**NEW YORK STATE THRUWAY AUTHORITY
DEPARTMENT OF ENGINEERING**

**AMENDMENT NO. 2
TO**

**CONTRACT TAN 26-14
D215082
PAVEMENT REHABILITATION AND MISCELLANEOUS
WORK ON I-190, NIAGARA THRUWAY
FROM MP N0.7 TO MP N4.2
IN THE BUFFALO DIVISION
OF THE NEW YORK STATE THRUWAY
IN ERIE COUNTY**

**IN THE LETTING OF
FEBRUARY 25, 2026**

TITLE OF PROJECT I-190 HIGHWAY REHABILITATION	CONTRACT NUMBER: TAN 26-14
LOCATION OF PROJECT I-190 NIAGARA THRUWAY MP 900.7 TO MP 904.2	DATE: FEB. 2026
TITLE OF DRAWING WZTC SOUTHBOUND SECTION 4/ PHASE 1/ STAGE 2	DRAWING NUMBER: TCP-96

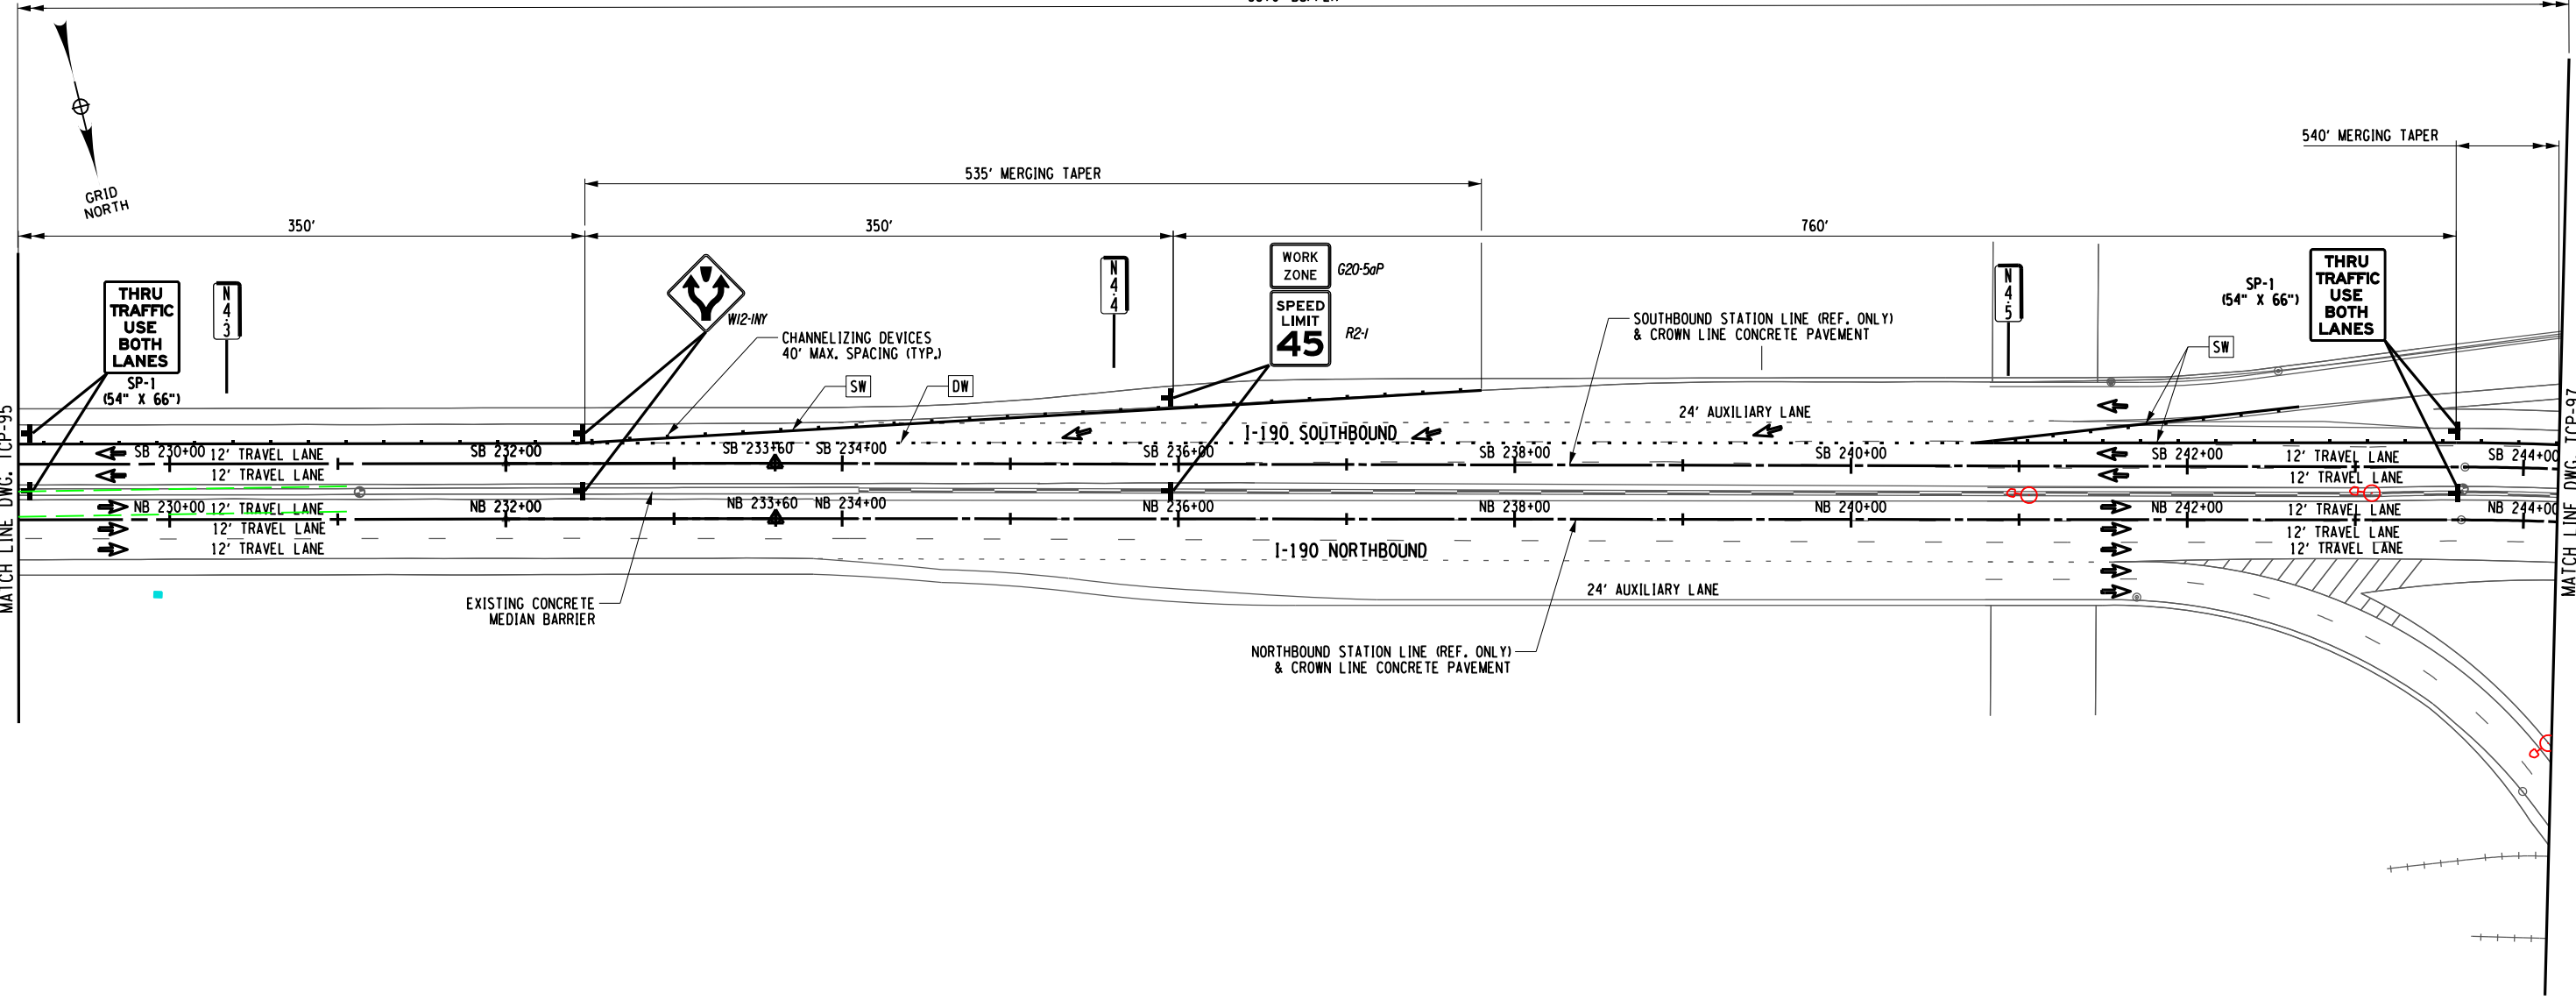
13. **DELETE** Drawing Number TCP-96, Sheet 135 of 421, and **SUBSTITUTE** with the attached Drawing Number TCP-96, Sheet 135-A2 of 421. “SP-1” signs were changed to fit field conditions, and the size of SP-1 sign was added to the sheet.

TITLE OF PROJECT I-190 HIGHWAY REHABILITATION	CONTRACT NUMBER: TAN 26-14
LOCATION OF PROJECT I-190 NIAGARA THRUWAY MP 900.7 TO MP 904.2	DATE: FEB. 2026
TITLE OF DRAWING WZTC NORTHBOUND SECTION 4/ PHASE 2/ STAGE 1	DRAWING NUMBER: TCP-102

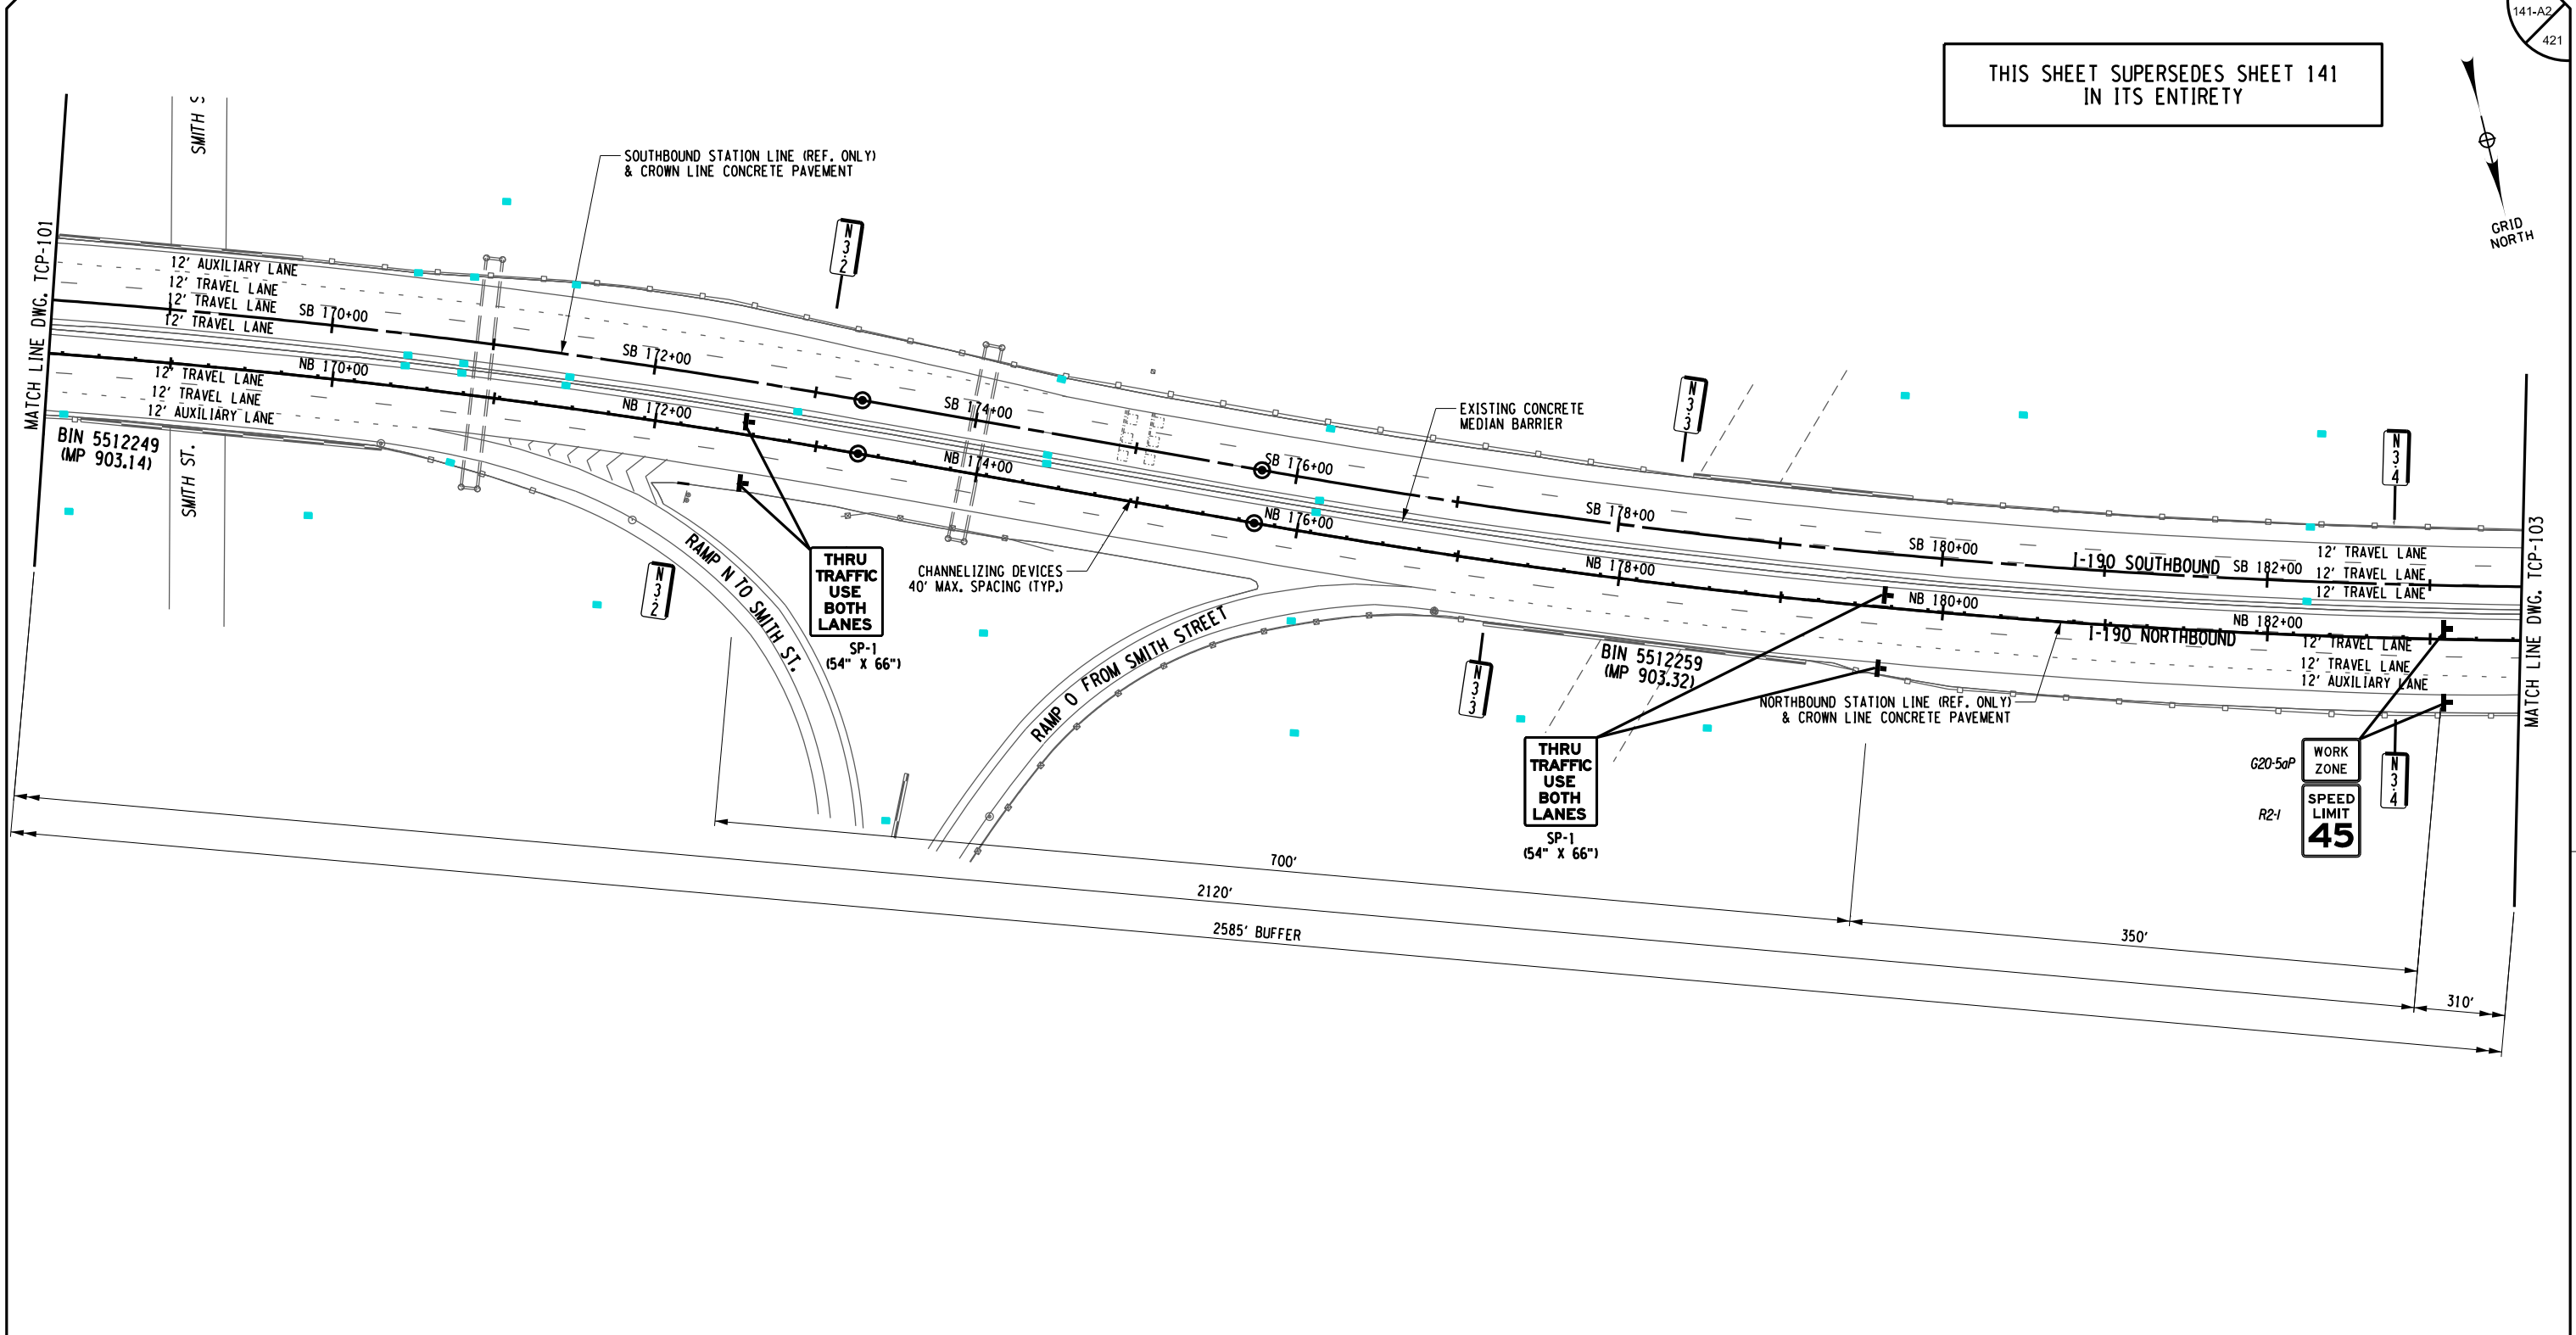
14. **DELETE** Drawing Number TCP-102, Sheet 141 of 421, and **SUBSTITUTE** with the attached Drawing Number TCP-102, Sheet 141-A2 of 421. “SP-1” signs were changed to fit field conditions, and the size of SP-1 sign was added to the sheet.

TITLE OF PROJECT I-190 HIGHWAY REHABILITATION	CONTRACT NUMBER: TAN 26-14
LOCATION OF PROJECT I-190 NIAGARA THRUWAY MP 900.7 TO MP 904.2	DATE: FEB. 2026
TITLE OF DRAWING WZTC NORTHBOUND SECTION 4/ PHASE 2/ STAGE 2	DRAWING NUMBER: TCP-111

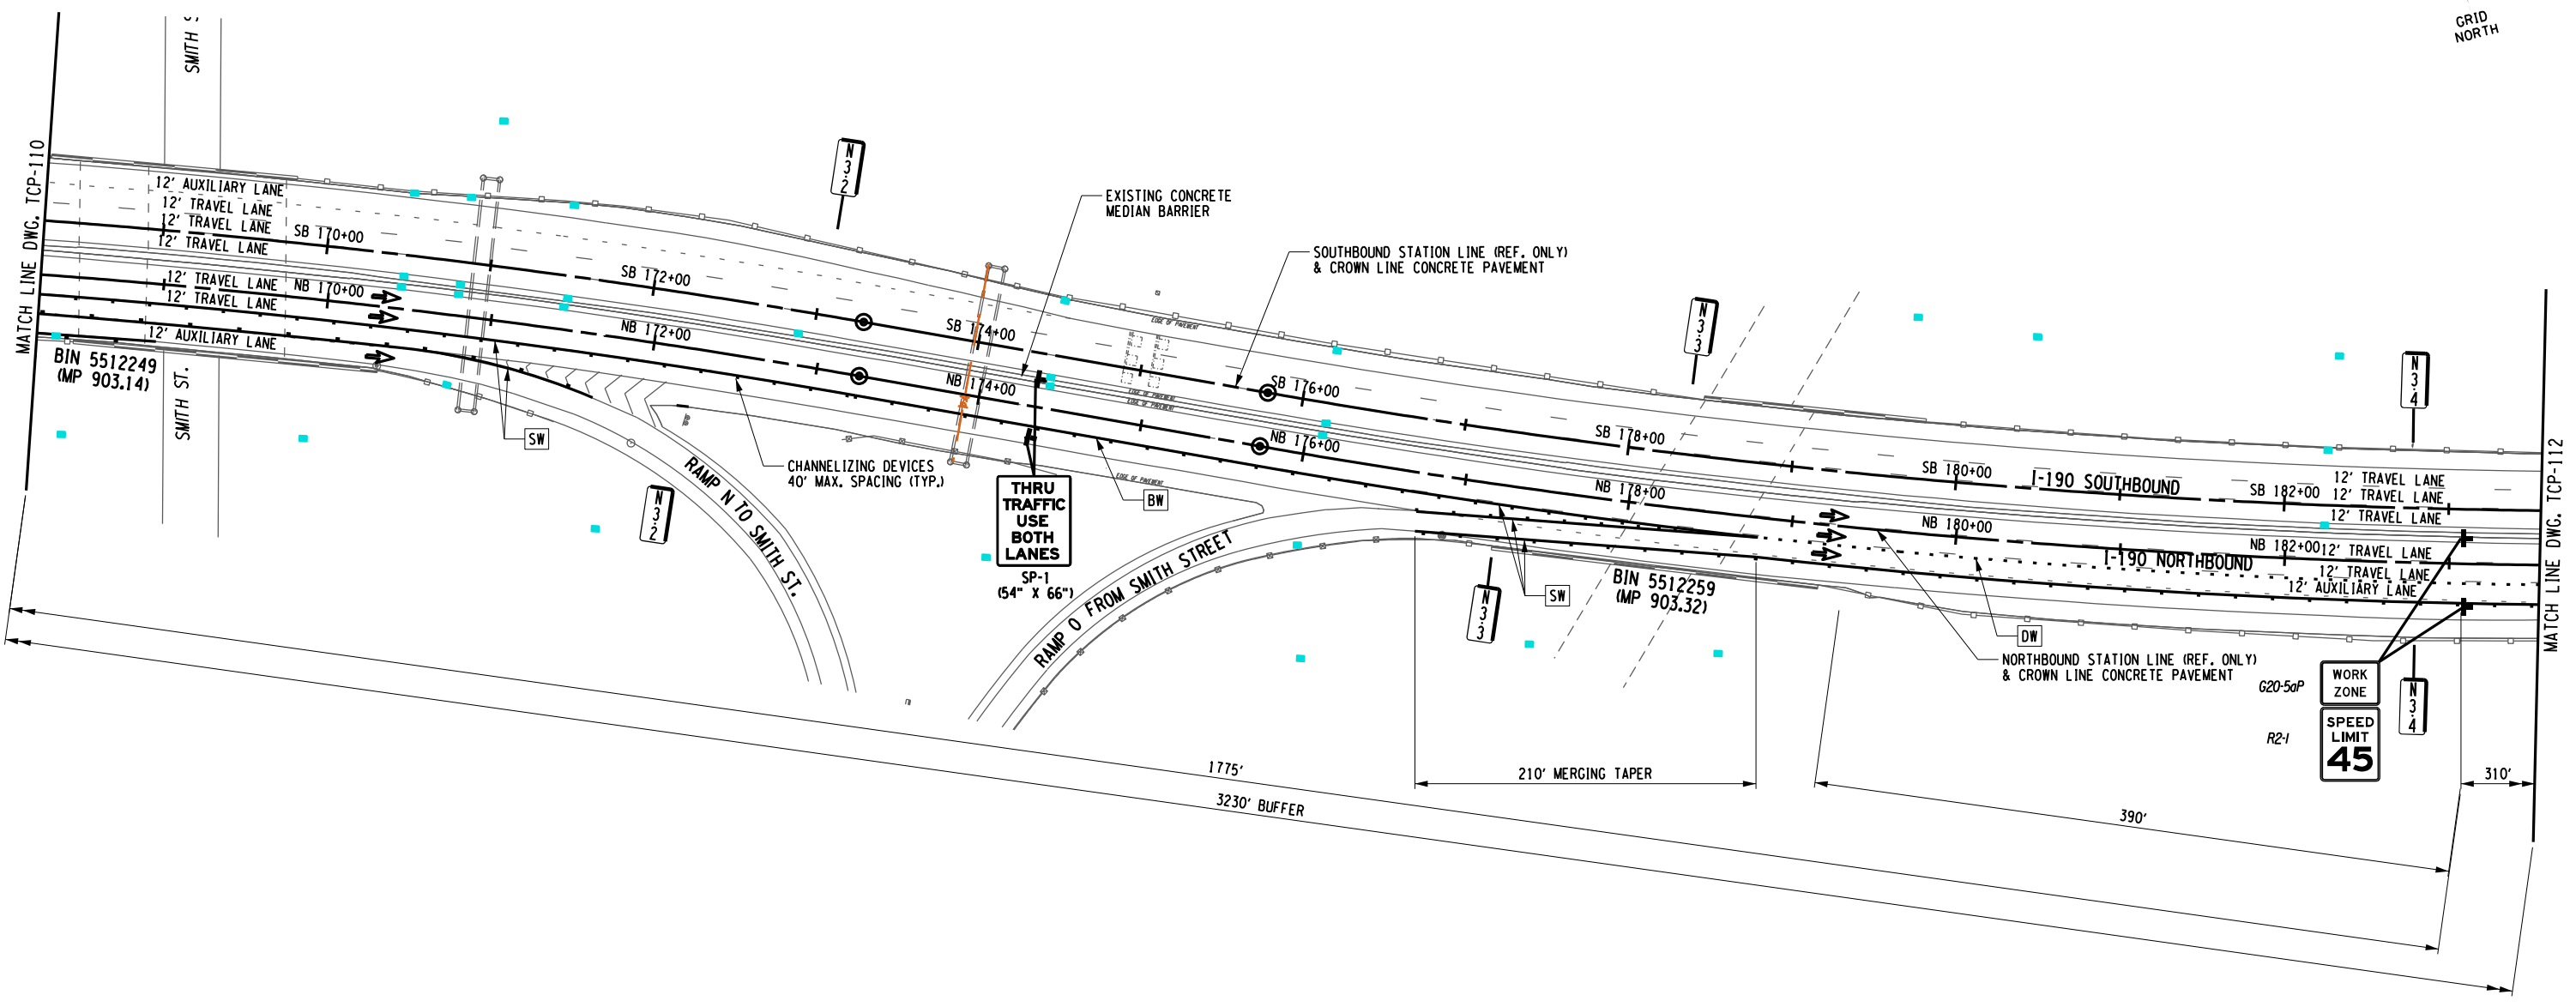
15. **DELETE** Drawing Number TCP-111, Sheet 150 of 421, and **SUBSTITUTE** with the attached Drawing Number TCP-111, Sheet 150-A2 of 421. “SP-1” signs were changed to fit field conditions, and the size of SP-1 sign was added to the sheet.

TITLE OF PROJECT I-190 HIGHWAY REHABILITATION	CONTRACT NUMBER: TAN 26-14
LOCATION OF PROJECT I-190 NIAGARA THRUWAY MP 900.7 TO MP 904.2	DATE: FEB. 2026
TITLE OF DRAWING WZTC NORTHBOUND SECTION 4/ PHASE 2/ STAGE 2	DRAWING NUMBER: TCP-112

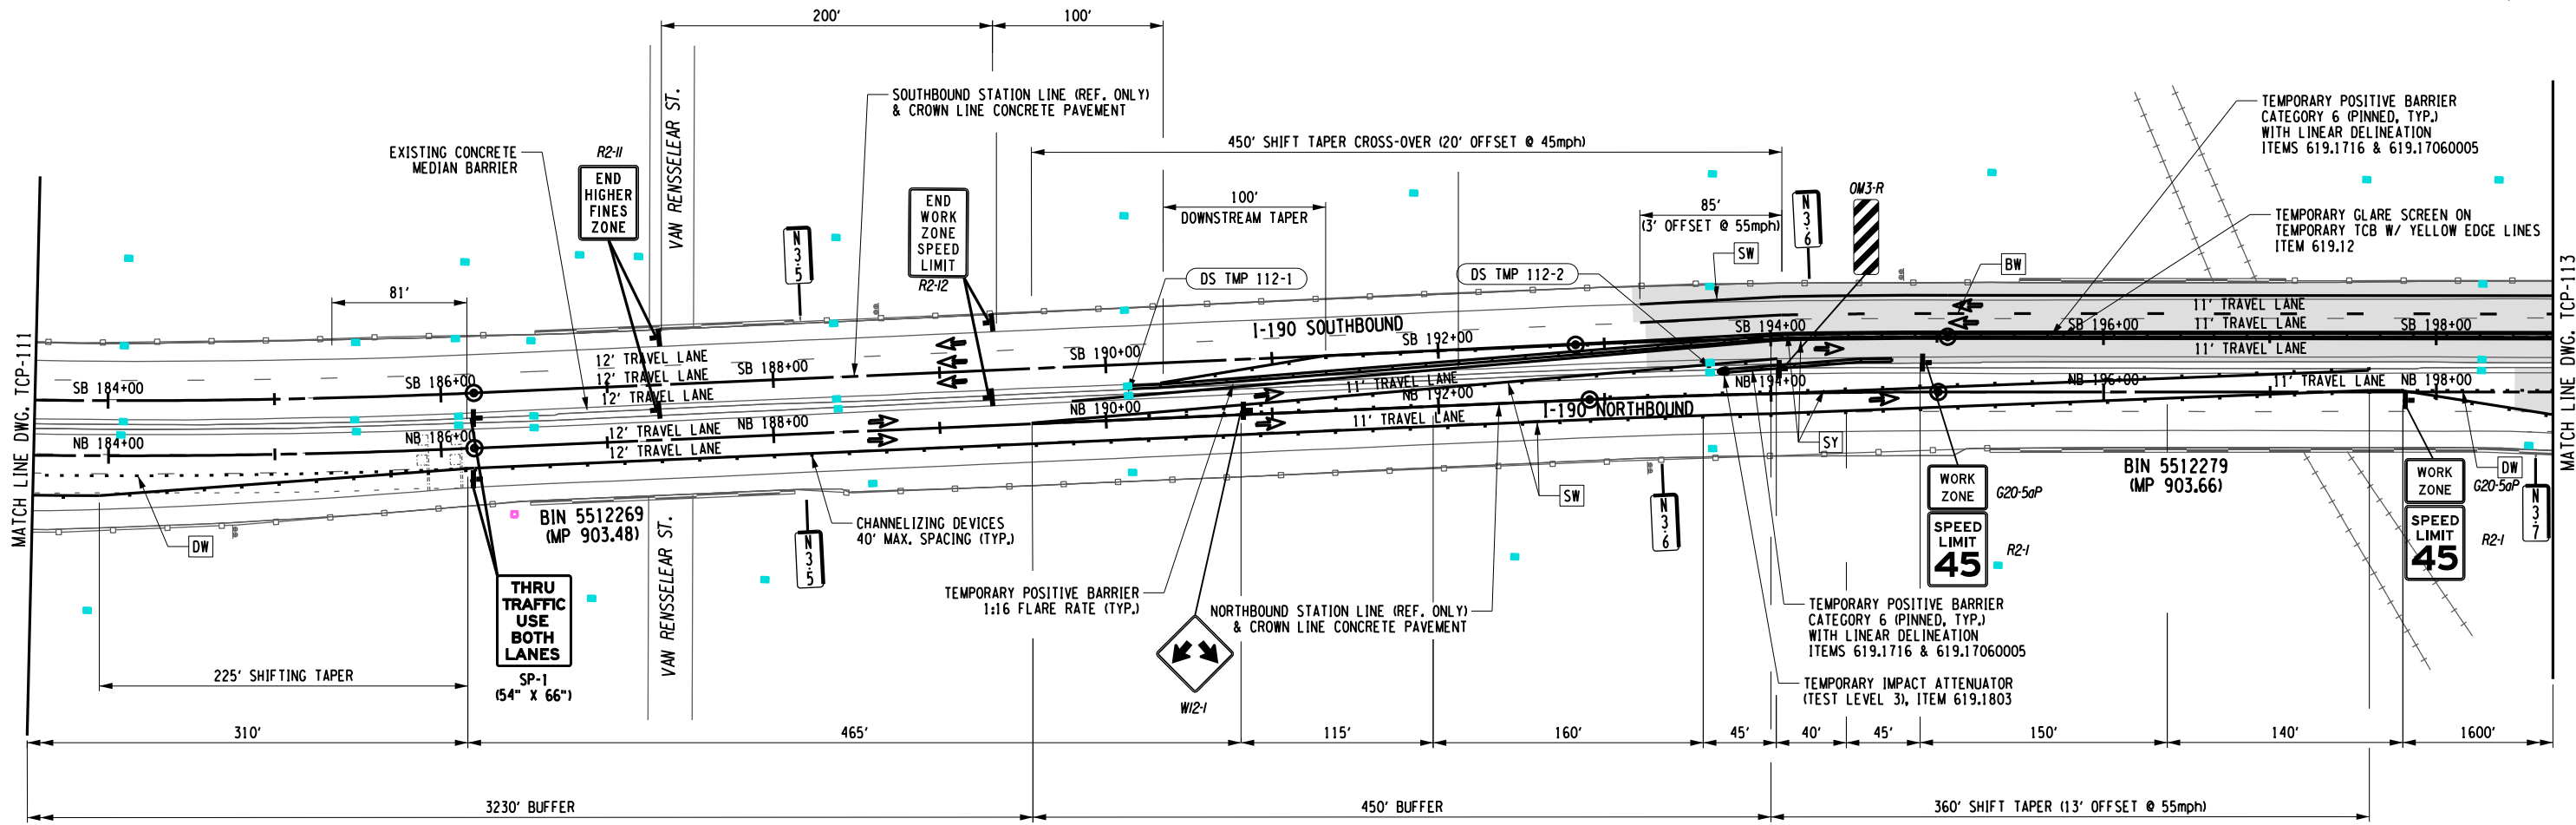
16. **DELETE** Drawing Number TCP-112, Sheet 151 of 421, and **SUBSTITUTE** with the attached Drawing Number TCP-112, Sheet 151-A2 of 421. “SP-1” signs were changed to fit field conditions, and the size of SP-1 sign was added to the sheet.
